# CITY OF ALBUQUERQUE

**RE: 3020 Rio Grande Blvd. NW**  
**Engineer's Certification Date: 10/05/23**  
**Engineer's Stamp Date: 02/21/23**  
**Hydrology File: G13D030A**

Based upon the information provided in your submittal received 10/05/2023, the Grading and Drainage Plan is approved for Building Permit and Building Pad Certification for 3020 Rio Grande Blvd. NW. Please attach a copy of this approved plan in the construction sets for Building Permit processing along with a copy of this letter.

ENGINEER'S SEAL	LOT 8-B ALVARADO GARDENS ADD 3020 RIO GRANDE BOULEVARD	DRAWN BY DEM
DAVID SOULE NEW MEXICO REGISTERED PROFESSIONAL ENGINEER 2/21/23	GRADING AND DRAINAGE PLAN	DATE 2-21-23
	Rio Grande Engineering P.O. BOX 53924 ALBUQUERQUE, NM 87199 (505) 321-9099	LOT 8-B Alvarado Gardens Addition.DWG
		SHEET # C1
		JOB #

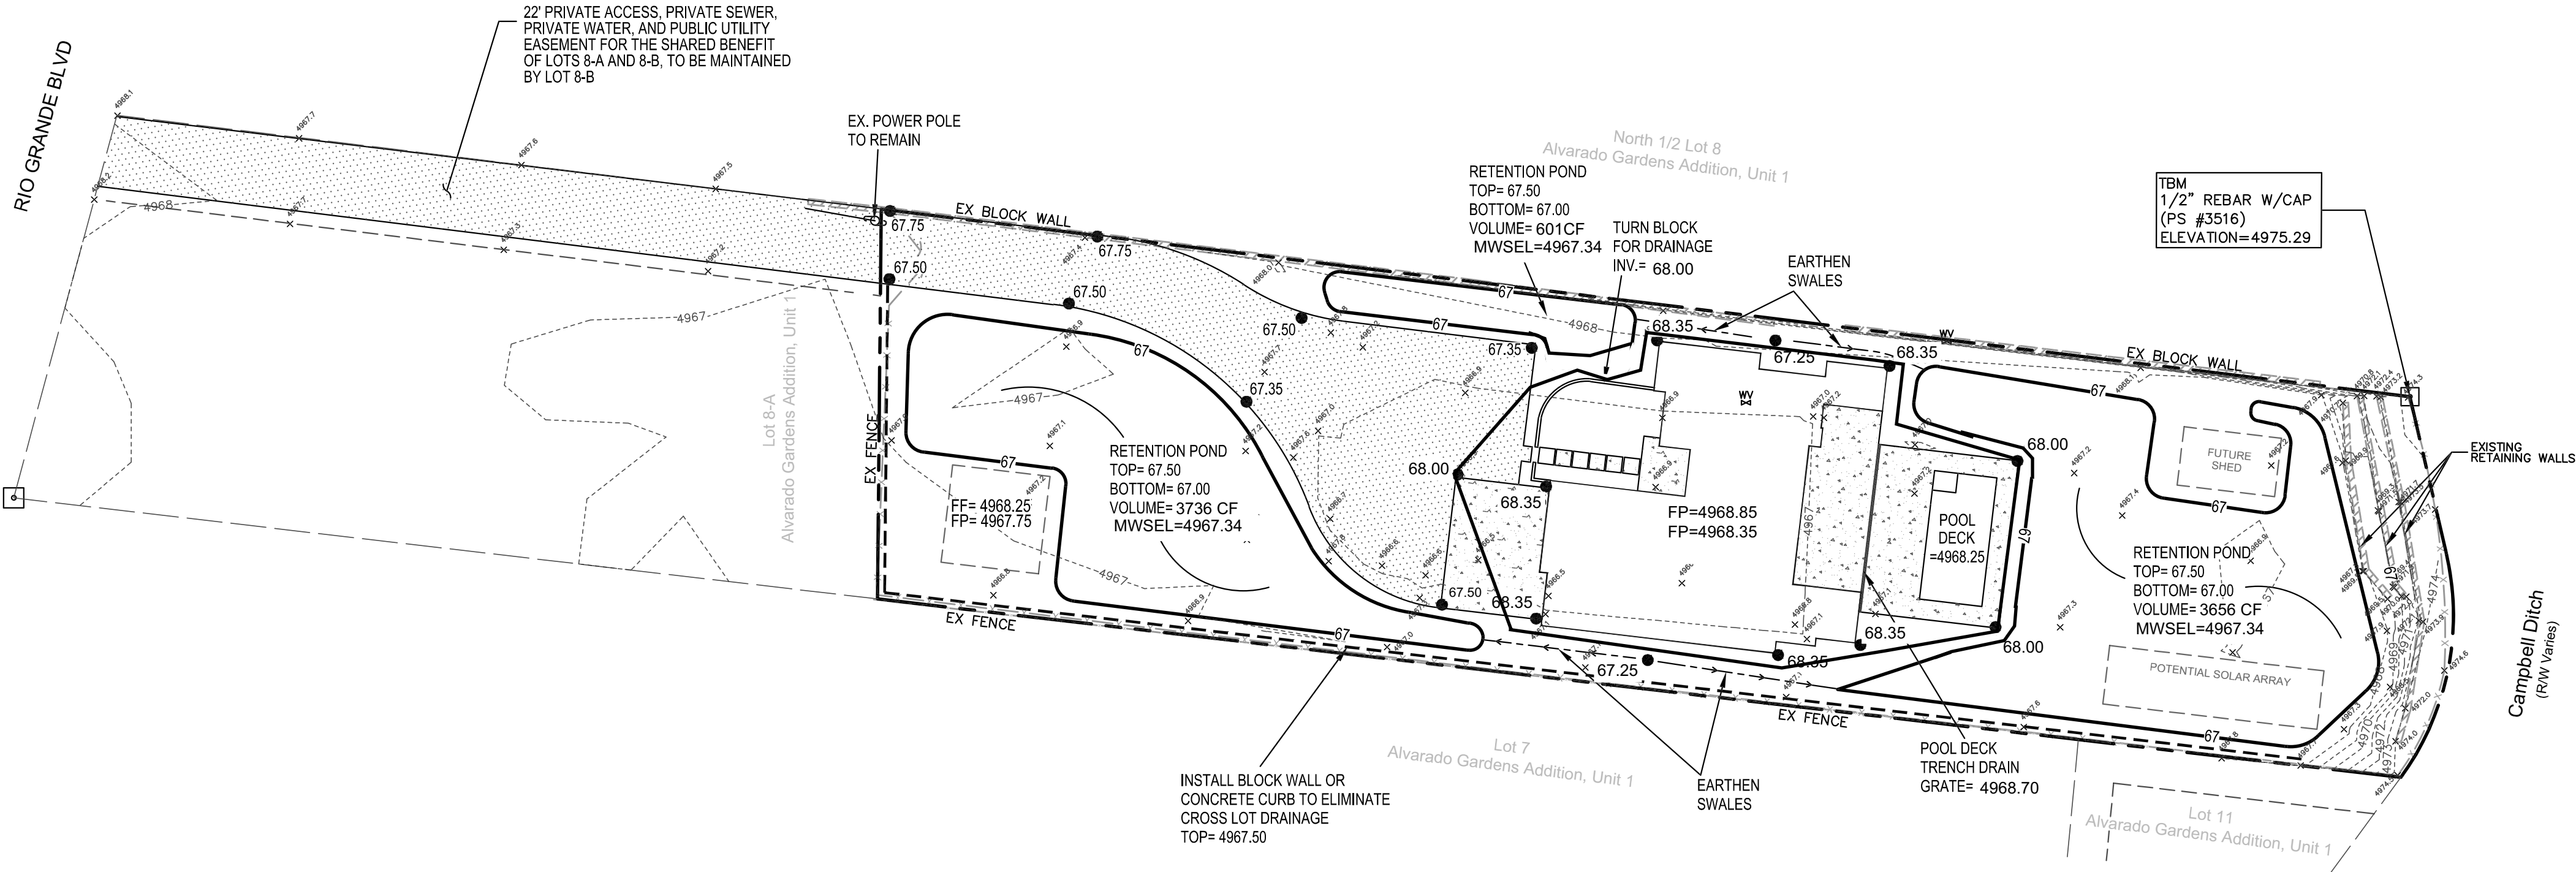
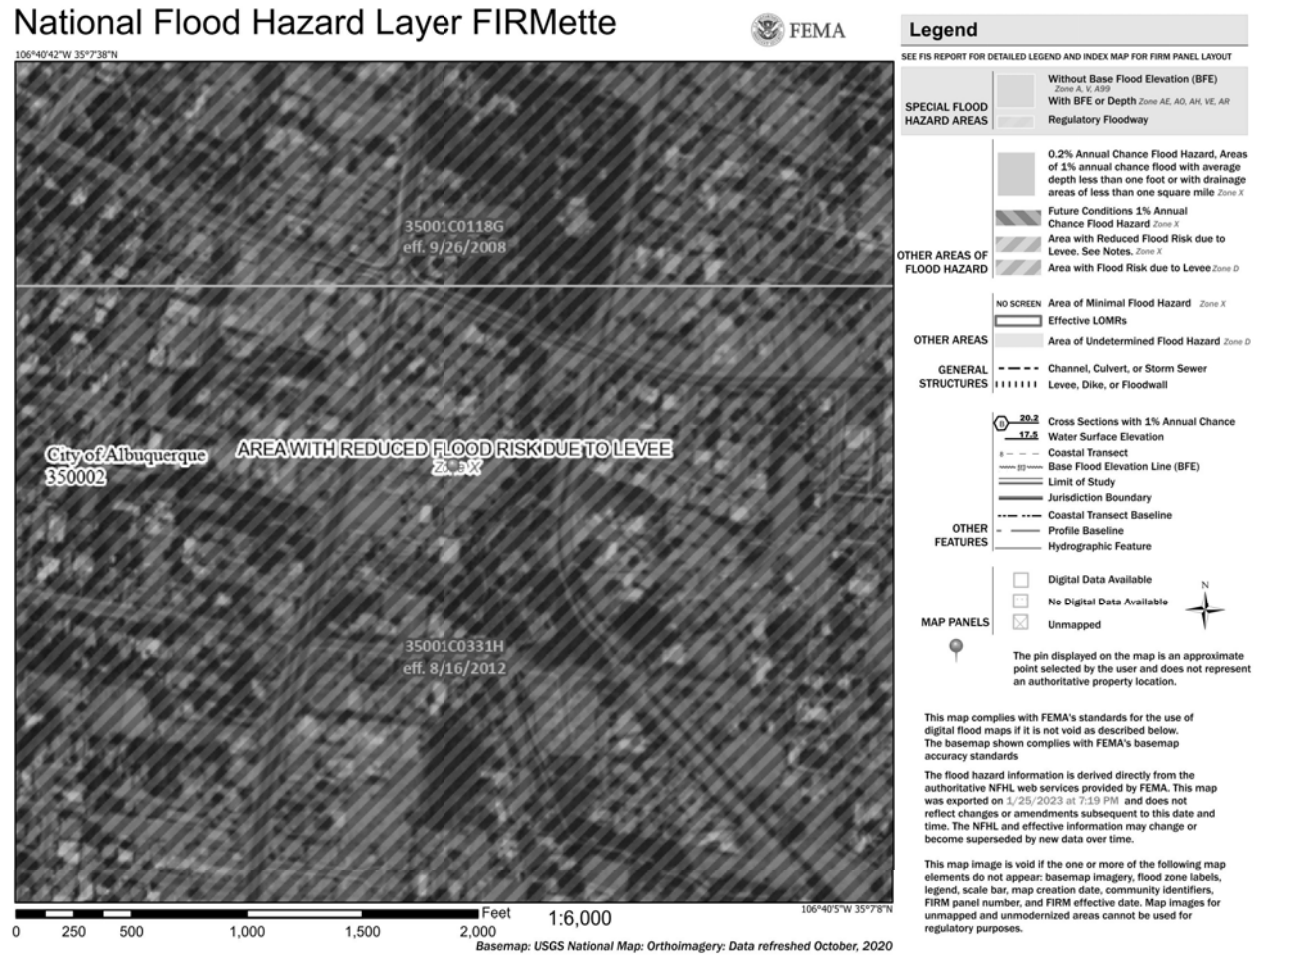
1. Engineer's Certification, per the DPM Part 6-14 (G): Engineer's Certification Checklist for Subdivision and Part 6-14 (H): Required Certification Language is required.
